# *Urban Design Consultation*

| **Proposal: Proposed erection of No. 2 dwellings and the insertion of additional vehicular and pedestrian access point following the demolition of the existing barn: Variation of condition 2 for 22/02051/FUL to amended plans for plot 2** | **Location: Former 79 Ugg Mere Court Road Ramsey St Marys** |
| **Case Officer: Lucy Pateman** | **Application: 25/00598/S73** |

The application follows approval of 22/02051/FUL and seeks to vary condition 2 to amend the plans for Plot 2 from drawing 280/P/02 B to 280/P/02 C and the site plan from 280/P/03 C to 280/P/03 D.

FRONT ELEVATION

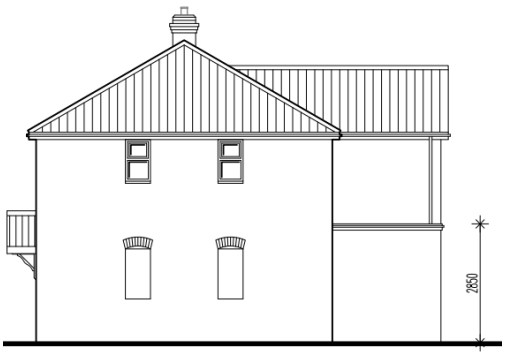
There is concern the appearance of the front entrance, flat roof porch canopy and 3 x full height landing windows landing creates a more contemporary appearance that fails to reflect the traditional proportions and details of other windows on plot 2. A single sash casement landing window together with a traditional 4-pane front door (suggest with side light(s)) is recommended to reinforce the traditional appearance of the dwelling:

**Recommendations: Minor amendments are recommended to the design of the hipped roof and the arrangement of doors and windows to reduce the perceived gable depth of the dwelling, reinforce the traditional appearance of the unit and break up the blank south facing gable.**

SIDE ELEVATION

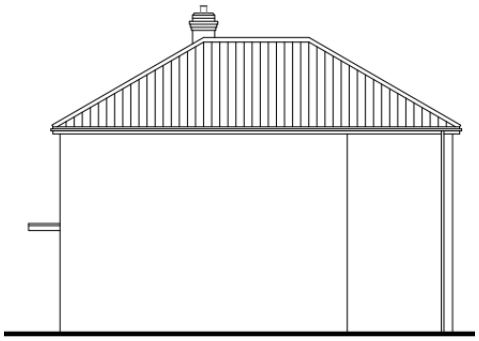
The propsoed side south facing elevation is entirly blank, whereas the approved application included two blind windows at ground floor and side bedroom 2 and 3 windows at first floor. Simialr window openings are required to break up this elevation in views looking north along Ugg Mere Court Road.
